**HISTORIC AND DESIGN REVIEW**  
**COMPLIANCE AND TECHNICAL ADVISORY BOARD**  
**June 21, 2024**

**HDRC CASE NO:** 2024-152  
**ADDRESS:** 250 QUENTIN DR  
**LEGAL DESCRIPTION:** NCB 6708 BLK 18 LOT 21  
**ZONING:** R-6, H  
**CITY COUNCIL DIST.:** 7  
**DISTRICT:** Monticello Park Historic District  
**APPLICANT:** Maziyar Entezami/ENTEZAMI MAZIYAR  
**OWNER:** Maziyar Entezami/ENTEZAMI MAZIYAR  
**TYPE OF WORK:** Roof reconstruction and modifications, exterior modifications, fencing  
**APPLICATION RECEIVED:** March 29, 2024  
**60-DAY REVIEW:** May 28, 2024  
**CASE MANAGER:** Edward Hall

**Historic and Design Review Commission**  
***Design Review Committee Report***

FLOOR LAYOUT  
ELEVATIONS

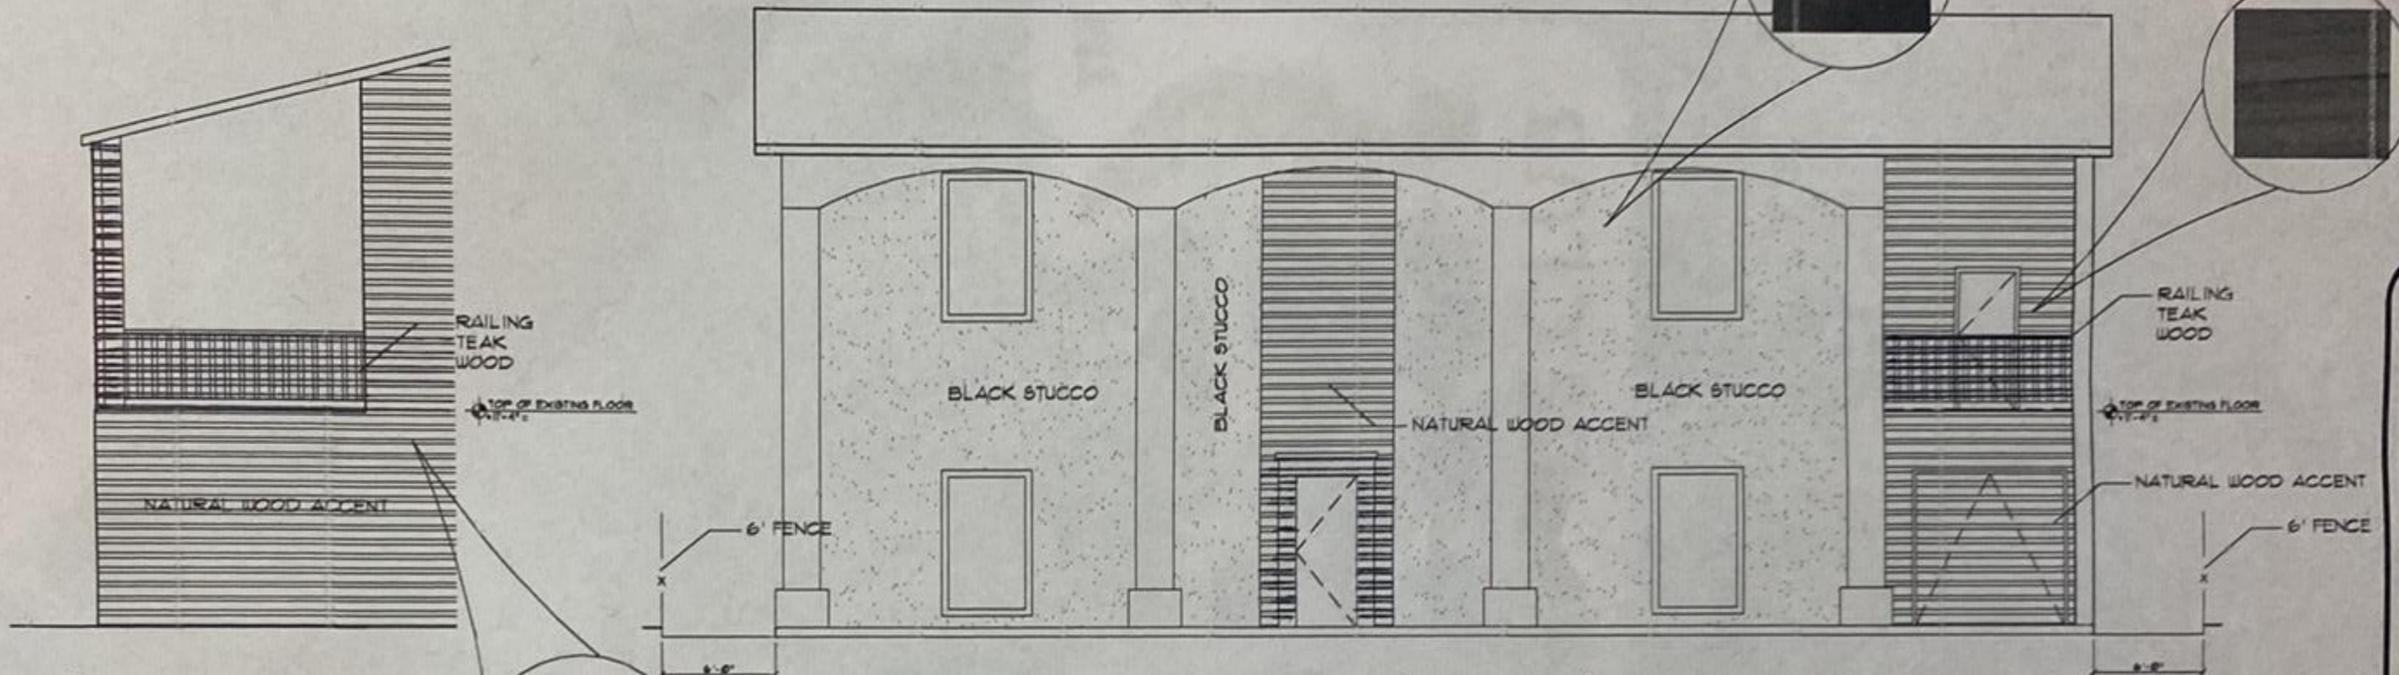
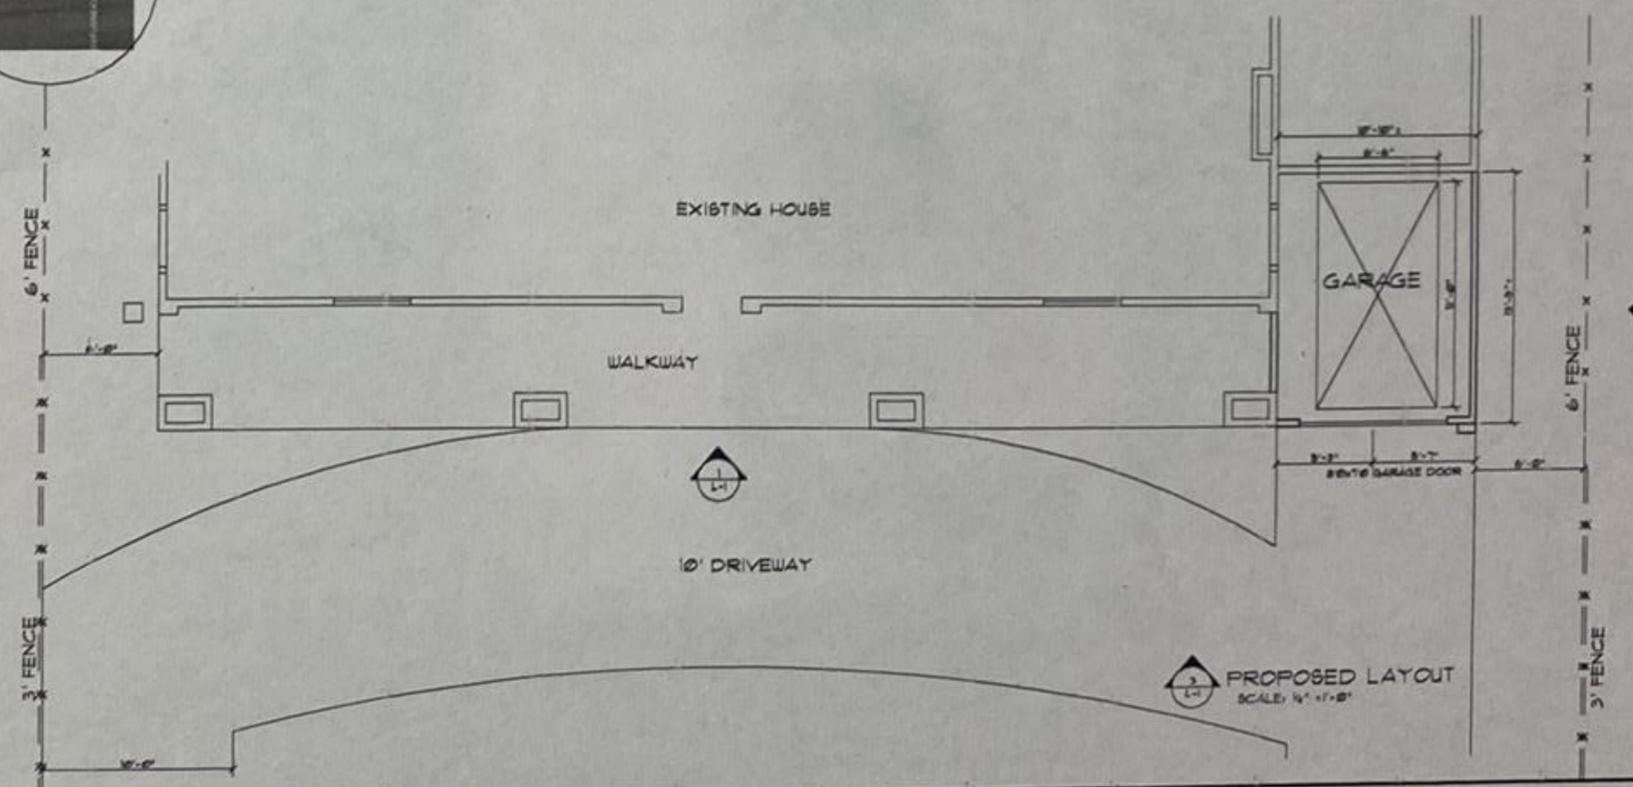
- e. ROOF RECONSTRUCTION – The applicant has proposed to reconstruct the fire damaged roof structure to feature a modified roof pitch and an increased ridge height over an existing side addition. The applicant has not proposed to reconstruct the previously existing chimney. The previously constructed roof featured modifications from the original profile and a modified ridge height. Generally, staff finds the construction of one, centered ridge line to be appropriate; however, staff finds that the side addition should maintain a subordinate ridge height, as was previously constructed. The Guidelines for Additions notes that the roofs of additions should feature subordinate ridge heights.

- g. FAÇADE MODIFICATIONS (Side Garage) – The applicant has proposed to modify the façade of the existing, side addition by installing a front facing garage door, a recessed balcony, wood siding and a fifth column. The proposed side addition’s mass will be extended forward to align with the primary façade of the historic structure. The 1941 Sanborn Map notes a garage in the location of the current side addition, where the applicant has proposed to install a garage. Staff finds the proposed request to add a garage door to be appropriate; however, staff does not find the proposal to extend the garage’s footprint forward to be appropriate. Staff finds that the garage’s footprint should remain the same and that the proposed door should feature wood construction or be profiled to appear consistent with those found historically within the Monticello Park Historic District. Staff finds that the façade materials should match the existing on site or that an architecturally and historically appropriate material be proposed for review and approval. Additionally, staff finds that additional construction documents should be submitted to OHP staff for review and approval noting the installation profile and depth of the proposed garage door. Staff does not find the installation of a fifth column to be appropriate.

JV & MS: Reconstructed roof is not appropriate and not in context with the existing examples within the district.

MS: By listening to the conversation at the hearing and by looking at previous photos, the roof as reconstructed is not appropriate. An alternative solution with a reduced ridge height should be considered. Additional comments on solutions that could be explored...lower plate heights, dormers, etc.

JV: Ridge height should be decreased.

1. Staff recommends approval of item #1, the reconstruction of the roof structure with the following stipulations:
  - i. That the side addition should maintain a subordinate ridge height, as was previously constructed.

- i. That the proposed garage’s footprint remain as it currently exists and not be brought forward.
  - ii. That the façade materials should match the existing on site or that an architecturally and historically appropriate material be proposed for review and approval. The proposed unfinished wood siding is not appropriate.

- iii. That additional construction documents be submitted to OHP staff for review and approval noting the installation profile and depth of the proposed garage door.

- iv. That the proposed fifth column be eliminated.
4. Staff does not recommend approval of item #4, fencing, as proposed. Front yard fencing is not found historically on this block of Quentin and is not common within the Monticello Park Historic District. Staff does not find the installation of front yard fencing to be appropriate. Staff recommends approval of privacy fencing, installed behind the front façade of the historic structure. A final site plan noting exact fencing locations is to be submitted to OHP staff for review and approval.
